**ITEM 13. DEVELOPMENT APPLICATION: 90-96 BOURKE ROAD AND 94A
COLLINS STREET ALEXANDRIA**

SUMMARY

Proposal Summary: The proposal is Integrated Development.

Figure 8: North west elevation – Bourke Road showing ground level hamper signage zones and vertically projecting wall signage.

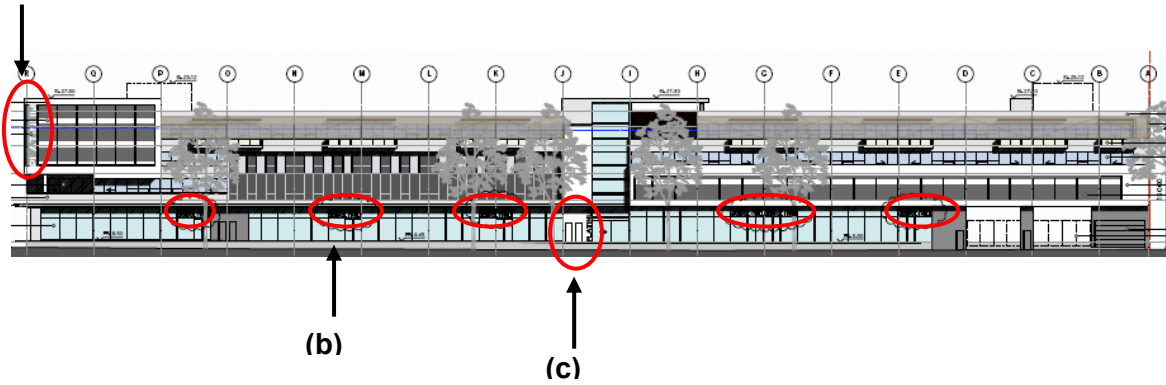
25. The application proposes building identification signage in the following manner:
- (a) Vertically projecting illuminated building identification signage extending over levels 2 and 3 at the corner of Bourke Road and Collins Street having dimensions 7.7m x 1.8m. The lettering is to be cut out of anodised aluminium (coloured platinum) affixed to white infill (signage details refer figures 8 and 9).

- (b) Ground level non-illuminated vertically projecting wall signage at the main entrances at Bourke Road and Collins Street each having dimensions 3.65m x 0.425m with 50mm raised lettering painted white (signage details refer figures 8 and 11).

28. The application also proposes 8 signage zones for hamper signage for the ground level tenancies along Bourke Road and Collins Street. The signage area is proposed to be located over each double door extending 1 window panel on either side of the door. Over single double door entrances signage is proposed to have dimensions 4.2m x 1.27m with entrances having 2 sets of combined double doors dimensions of 8.4m x 1.27m (signage details refer figures 8 and 10).

29. It is also noted that the larger ground level bulky goods retailing showrooms have up to three doors accessing each tenancy. Whilst the DCP only allows 1 sign per shopfront tenancy and of not more than 1m² in area, given the scale of the building extending approximately 141m along Bourke Road and 75m along Collins Street, its setback from Bourke Road and Collins Street of 6.0m and 4.0m respectively and the generous distances between the access doors to each of the tenancies that the proposed number and size of signage zones is considered appropriate in this instance.

26. The DCP allows up to 3 building identification signs per building. The main entrance signage is of a size that is appropriate to the size of the Bourke Road and Collins Street frontage.
27. Typically, signs between the first floor and parapet should extend no more than 1 level. The proposed building identification sign extends over 2 levels. Notwithstanding, given the set back of the building of 6.0m from Bourke Road and 4.0m from Collins Street, the building extending approximately 141m along Bourke Road and 75m along Collins Street and the high degree of compatibility with the architectural design of the building the proposed signage is considered to be acceptable.

Figure 12: Plan showing location of planned through site link.

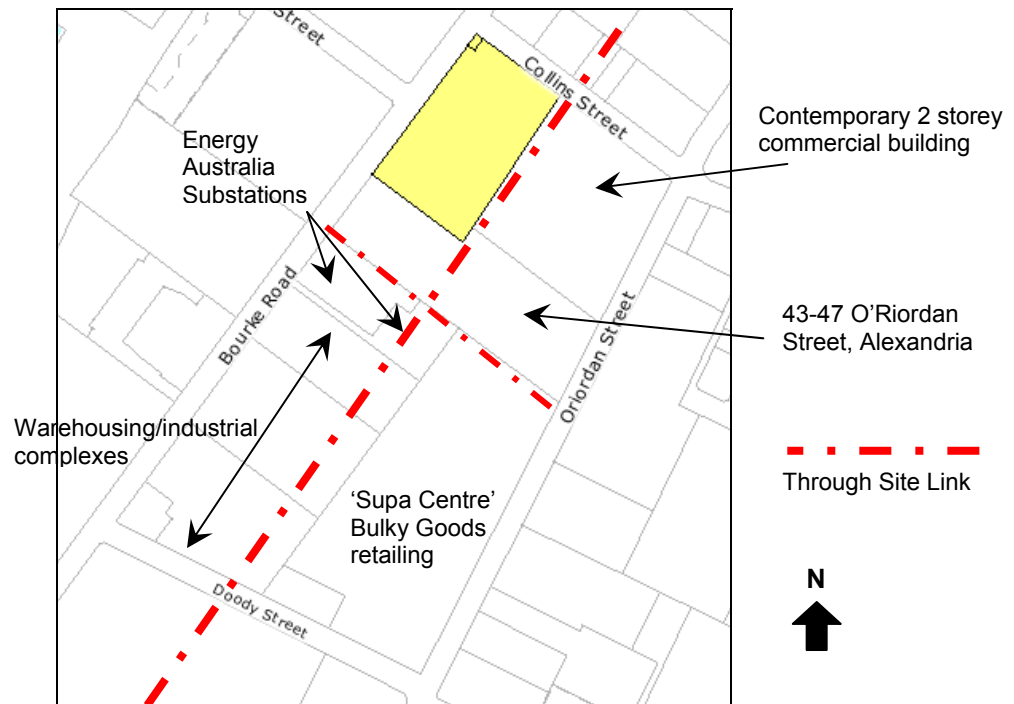
42. The Southern Industrial Public Domain Plan identifies mid-block connections to be implemented for new developments in large industrial sites in order to improve pedestrian access and connections between privately owned large industrial sites.
43. The through site link has not been provided in surrounding sites bounded by Collins Street to the north, O'Riordan Street to the east, Doody Street to the south and Bourke Road to the west. Generally these sites comprise bulky goods retailing and warehousing industrial complexes. The sites fronting Bourke Road are potential redevelopment sites and may be able to incorporate the through site link as proposed.

44. Whilst the DCP indicates the provision of a through site link it is not precise enough to determine whether the link passes through the subject site. If a through site link was to be provided on the subject site it would run alongside the proposed large vehicular service driveway which runs down the length of the site's south eastern boundary raising safety concerns.

45. Given the north-south orientation of the street block, it is more appropriate to have any mid-block pedestrian connections in the middle of the long side of the block to improve east-west links. This is provided for to the south of the site.

Figure 13: Site to the south – Existing building to be retained extends across the whole of the site boundary of the subject site to the north.

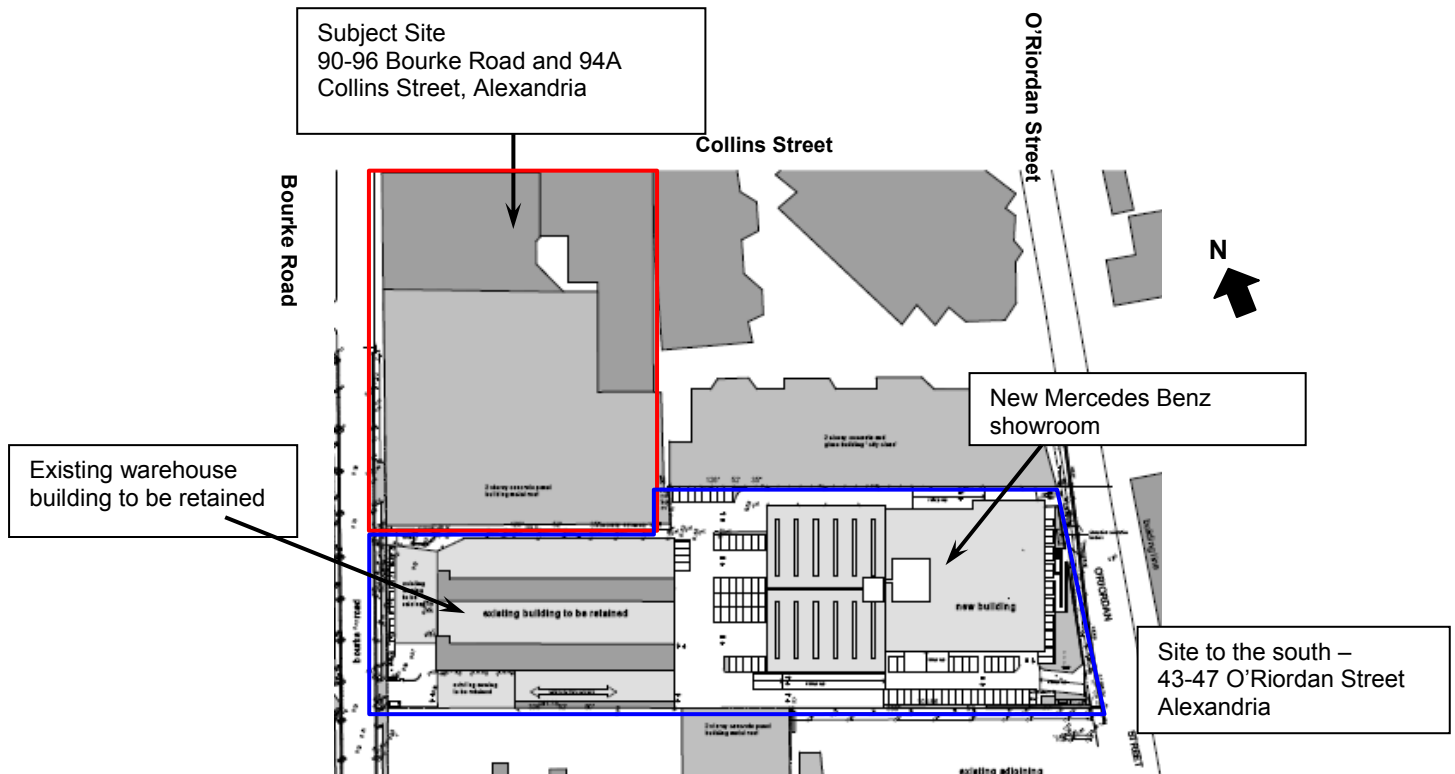
48. In addition, this warehouse building which extends more than the entire length of the southern boundary of the subject site makes the provision of a mid block connection untenable (refer **figure 13** below).

Figure 14: Cross section showing some of the stated setbacks at Bourke Road.

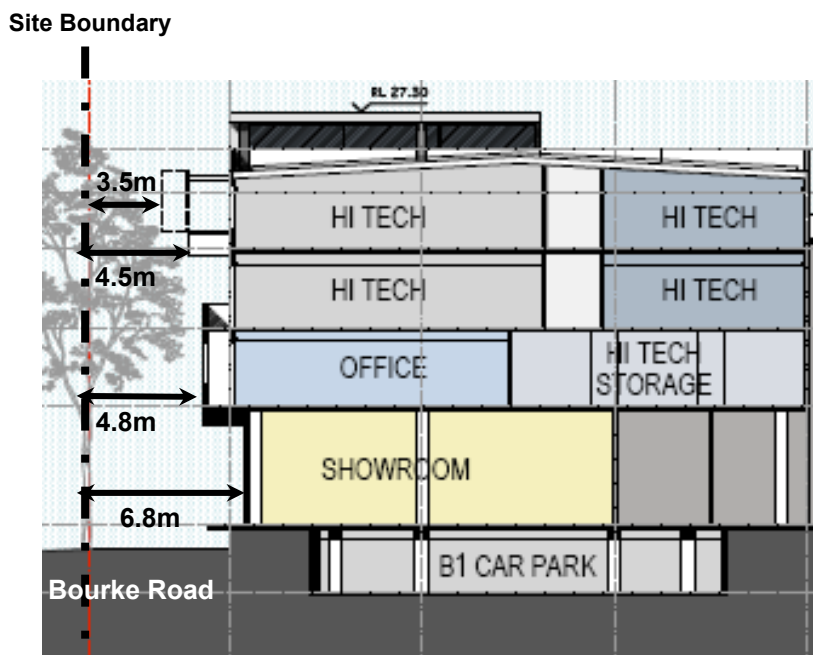
49. Part F – Design Criteria for Specific Types, Section 3 – Industrial Development, Part 3.2 – Building form and appearance of the South Sydney Development Control Plan 1997 requires that a “*minimum setback of 6 metres is required along the City’s major roads ... clear of all obstructions including signage, parking and building overhangs and is suitably landscaped to form a natural extension to the Public Domain*”.
50. The proposed building setback to Bourke Road is 6.8m at ground level. However the ground level and L3 awning structures cantilever over the setback area providing a setback of 3.4m and 3.5m respectively from the site boundary (and an additional 3.7m from the roadway) with upper level balcony setbacks ranging between 4.5m and 4.8m from the site boundary.

51. The setback encroachments are acceptable in this instance as:
- the setback encroachments do not impact street tree plantings and on-site landscaping;
 - the setback at Collins Street is greater than required ranging between 4.2m and 14.6m as a result of retaining the fig trees and incorporating into the landscaping. This is a positive outcome for the site and it is therefore reasonable to allow some flexibility to the Bourke Road setbacks.
 - the variation of setback contributes to the modulation and articulation of the long building façade and
 - the development makes a positive contribution to the streetscape, surrounding development and the renewal and future character of the industrial area in general.

Figure 15: Driveways at eastern corner of Collins Street showing proposed vehicular entry/exit arrangement.

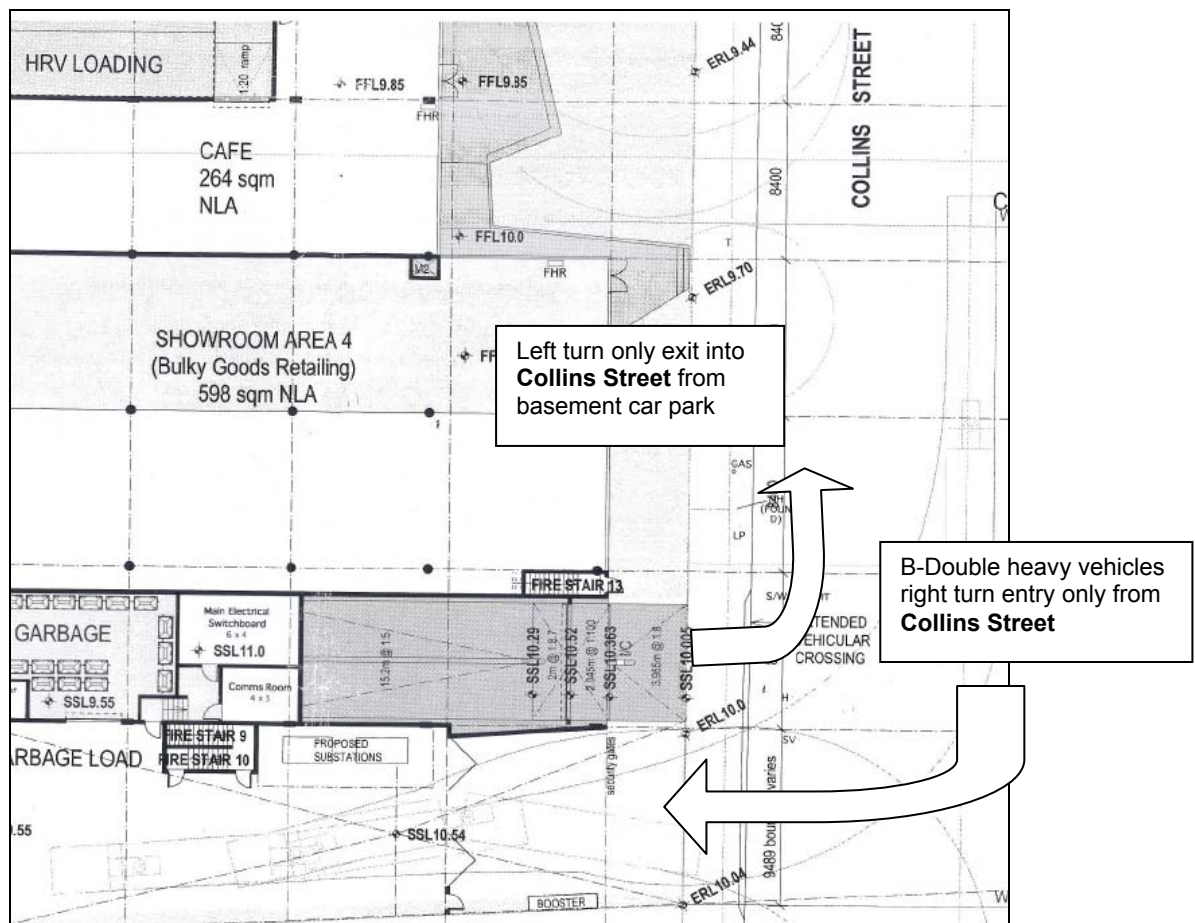
- (a) **Impact of 2 side by side driveways on site immediately opposite being 39 Collins Street.**

Comment: Conditions of consent should be applied restricting the use of the Collins Street entry to B-Double vehicles, right movement in only and exit only from the basement car park for left turning traffic only. The applicant is to submit a management plan detailing how the driveway will be designed to restrict its use by other vehicles. These restrictions will limit impacts of queuing along Collins Street by controlling the number and type of vehicles entering the Collins Street driveway. The applicant advises that the frequency of B-Doubles accessing the site, primarily to service the needs of Yalumba Wines will be 2 deliveries per week. Please refer to the diagram below for further explanation.

Comment: The B-Doubles vehicles are to be restricted to a right movement in only into the Collins Street driveway (with exit left only onto Bourke Road). The infrequency of the B-Doubles entering and exiting the site from Collins Street will reduce any vehicular/pedestrian safety concerns.
